SUBJECT: REQUEST FOR AN AMENDMENT TO LICENSE NUMBER 21-01354-03 DATED MARCH 23, 1984  
AND OUR REQUEST FOR ADDITIONAL INFORMATION DATED DECEMBER 6, 1984  
AND FOLLOW UP PHONE CONTACT ON JANUARY 7, 1985

# Leila Hospital and Health Center

This is in reference to a report dated April 13, 1984, signed by Joseph P. Ohlmacher, describing the results of a radiation survey of your cobalt-60 teletherapy unit. In order to complete our evaluation of the report, we need the following additional information:

Radiation Safety Survey  
April 13, 1984

# Figure F-1 TELETHERAPY HEAD SURVEY

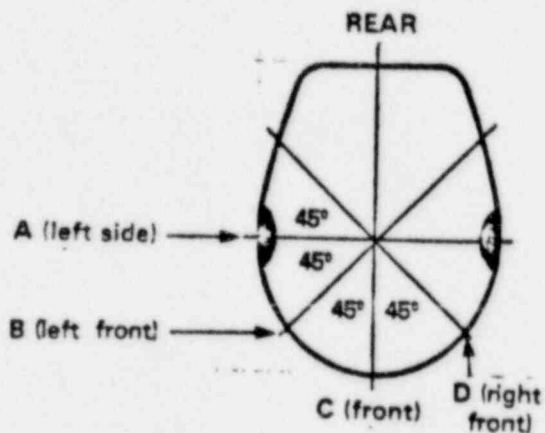
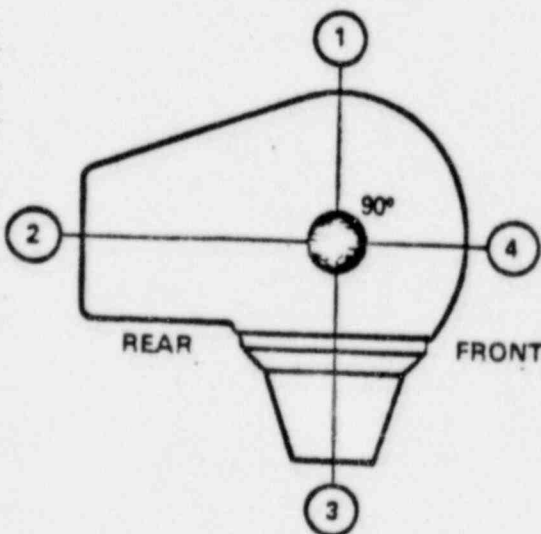
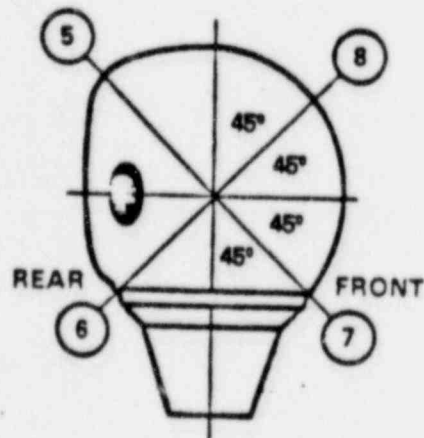
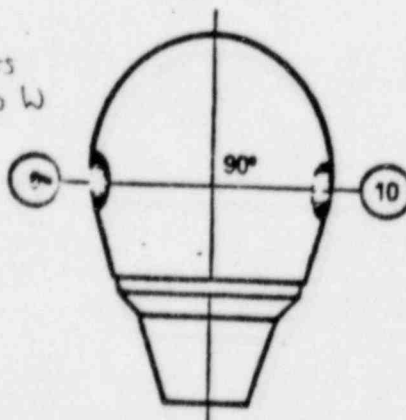
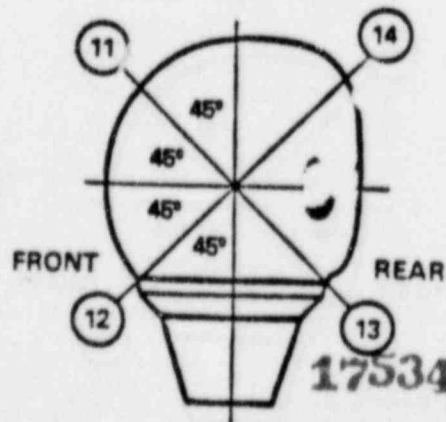
6. Please submit the date the old source was transferred from the licensee as well as the name, address and license number of the recipient.
7. You have not described the tests that were conducted to ensure the proper operation of the safety interlock systems. Please describe the tests that were conducted to ensure proper operation of:

- a. Room doors. The door is closed normally and observed to latch. The source is turned on. This is verified by observation of enunciator lamps on the control console, warning lamps over the room door, inside the treatment room, and on the source head, and proper operation of the "Primalert" radiation detector unit. The room door is opened sufficiently to trip the interlock switch (this is normally just slightly ajar). The source is observed to turn off by noting transition of the above conditions to a "Off" indication. With the door ajar, several attempts are made to return the source to an "On" condition. These attempts include turning the keyswitch on the console, resetting the timer, and then turning the keyswitch.

- b. We have methods of cross-checking source condition. There is a G-M type monitor installed with a back-up nickel-cadmium power source in the treatment room. (Nuclear Associates "Primalert 10", Model 05-433.) The position of the source wheel can be seen via either the television system or the mirror system normally used for patient observation. Status of the source position lights on the source head can also be seen.
- c. Interception of the beam is determined by noting the status of the "Zone-guard" enunciator lamp on the source head. The source cannot be turned on with this lamp indicating a disallowed position.
- d. This condition is checked by attempting to turn the source on after a normal shut-off by the timer.
